SUBJECT: CALLAWAY PLANT, UNIT 1 – STAFF ASSESSMENT OF RESPONSE TO 10
CFR 50.54(f) INFORMATION REQUEST – FLOOD-CAUSING MECHANISM
REEVALUATION (TAC NO. MF1096)

STAFF ASSESSMENT OF RESPONSE TO 10 CFR 50.54(f) INFORMATION REQUEST

CALLAWAY PLANT, UNIT 1

Figure 3.2-1: HEC-HMS subbasins delineated on the Callaway Energy Center site (from the RAI response (Reasoner, 2014a), Figure 2-2).

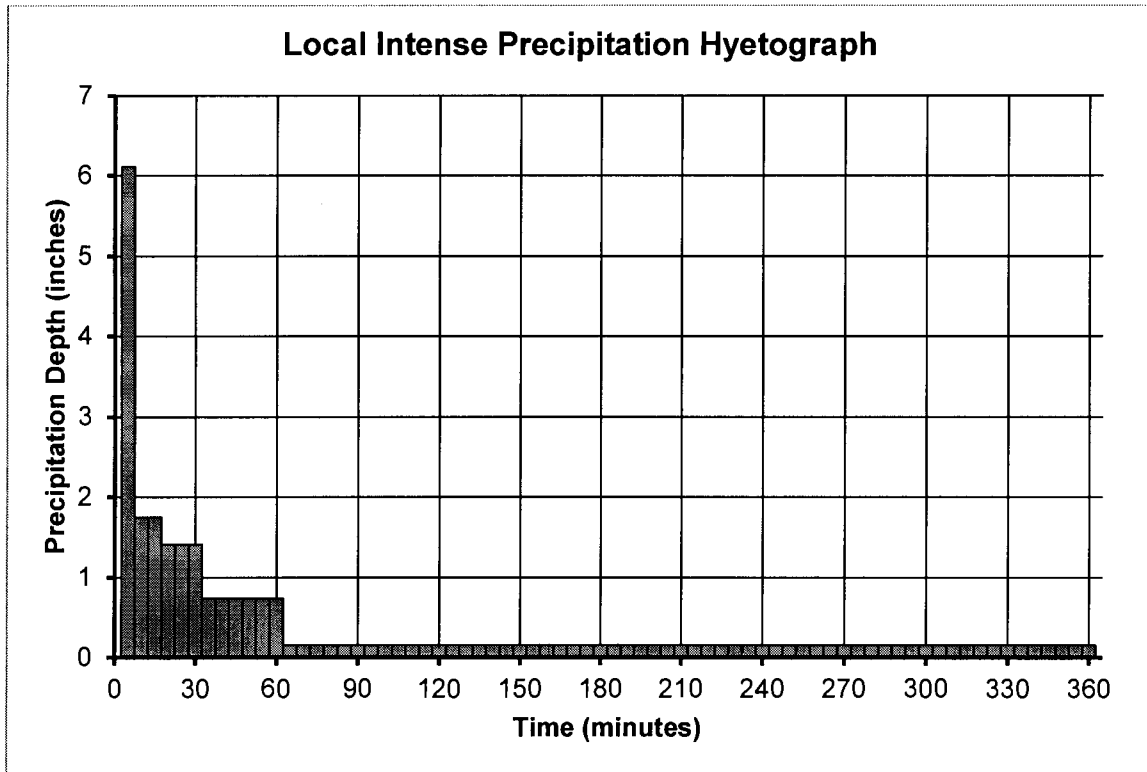
For the purpose of reevaluating the effects of LIP flooding, the licensee delineated 51 subbasins on the Callaway site as shown on Figure 3.2-1, of which 7 subbasins (24, 30, 31, 50, 51, 56, and 58) contain safety-related SSCs. The staff noted additional information on the site and subbasin delineations was needed in order to complete the review. Accordingly, the staff issued two RAIs (NRC, 2014a), requesting a discussion of the delineation of subbasins, as well as electronic versions of digital elevation models, input and output files of the LIP model, and relevant graphical information system files that were used by the licensee in LIP modeling. In its response dated February 27, 2014 (Reasoner, 2014a), the licensee provided the requested information for the staff's review.

FHRR Section 3.2.1.4 describes the procedure and results of analyzing LIP flooding coincident with wind effects on the UHS retention pond. The licensee noted in its FHRR that the UHS retention pond is a small body of water and is not subject to significant surges and seiches. The licensee also stated that other combined and associated effects coincident with LIP flooding are not applicable at the UHS retention pond. Figure 3.2-1 shows the location of the UHS retention pond (Subbasin ID 58).

The staff noted that the licensee's analysis for LIP Scenario 5 showed another area of ponding (HEC-RAS subbasin 22 in Figure 3.2-1) that had both a larger maximum dimension and a higher water elevation than the UHS retention pond. The staff issued RAI 12 (NRC, 2014a) to clarify this issue. In its response to RAI 12, the licensee clarified that their modeling of water surface elevations in subbasin 22 was based on a temporary situation involving an open excavation in that area, and presented HEC-RAS modeling results indicating that re-grading of the excavated area would reduce ponding, resulting in a somewhat lower peak flood elevation. Because the predicted area of ponding in subbasin 22 is at least 250 ft (76 m) away from the

Figure 3.3-1: Map of the combined watersheds of Auxvasse Creek, Logan Creek, and Mud Creek (from the FHRR Figure 3-6).

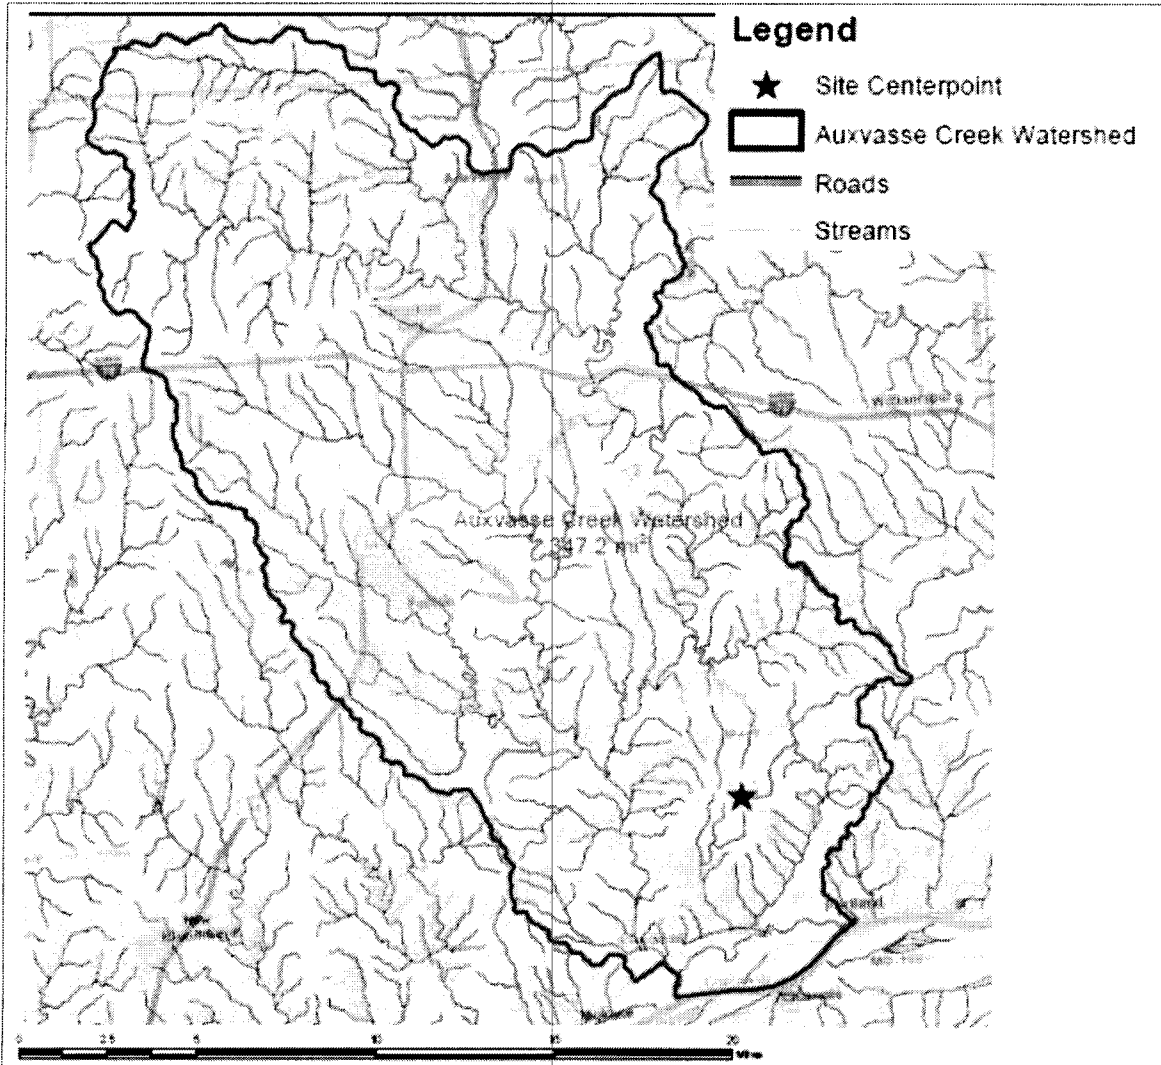
The licensee reviewed nearby streams and rivers to identify sources of potential flooding hazards. The licensee screened out flooding from the Missouri River because the highest flood of record on the river was approximately 304 ft (93 m) below the site grade. Instead, the licensee identified three nearby creeks: Auxvasse Creek, Logan Creek, and Mud Creek. The "Auxvasse Creek Watershed" mentioned in the FHRR includes these three watersheds (see Figure 3.3-1).

Figure 3.3-2: Rainfall hyetograph for 72-hour probable maximum storm, showing rainfall rates for 5-minute time periods (from the FHRR Figure 3-7).

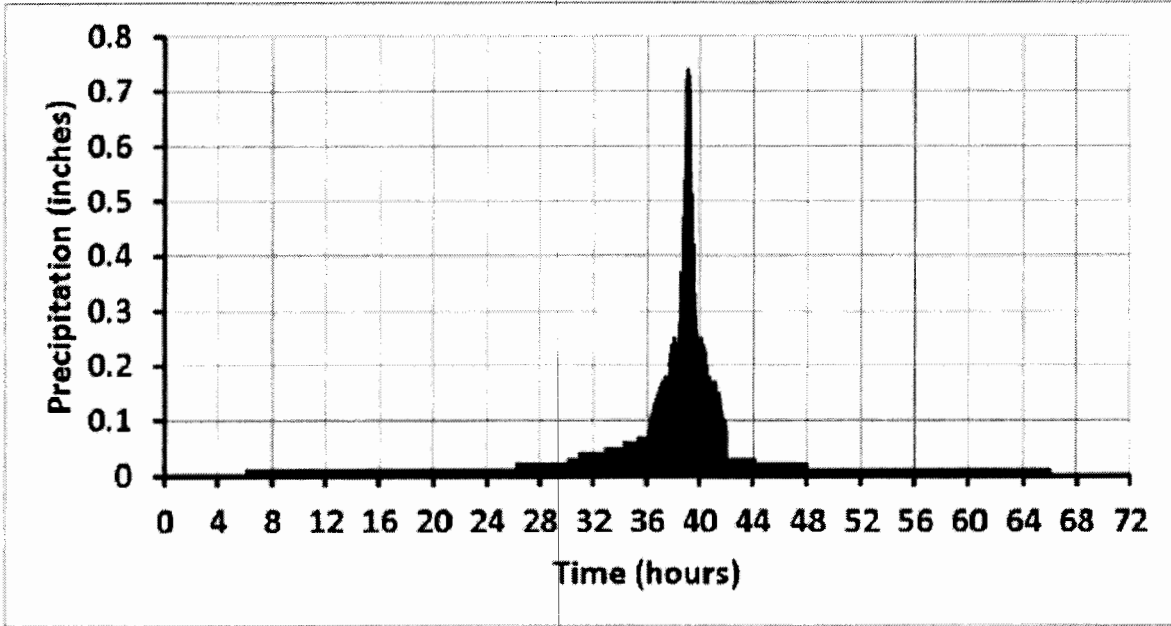
methodologies and regulatory guidance. For the watershed area, the licensee determined a critical storm area of 300 square miles (777 km²), a storm orientation of 150 degrees, and a 72-hour PMP depth of 28.6 in (72.7 cm). Figure 3.3-2 shows the rainfall hyetograph the licensee developed for this PMP event.
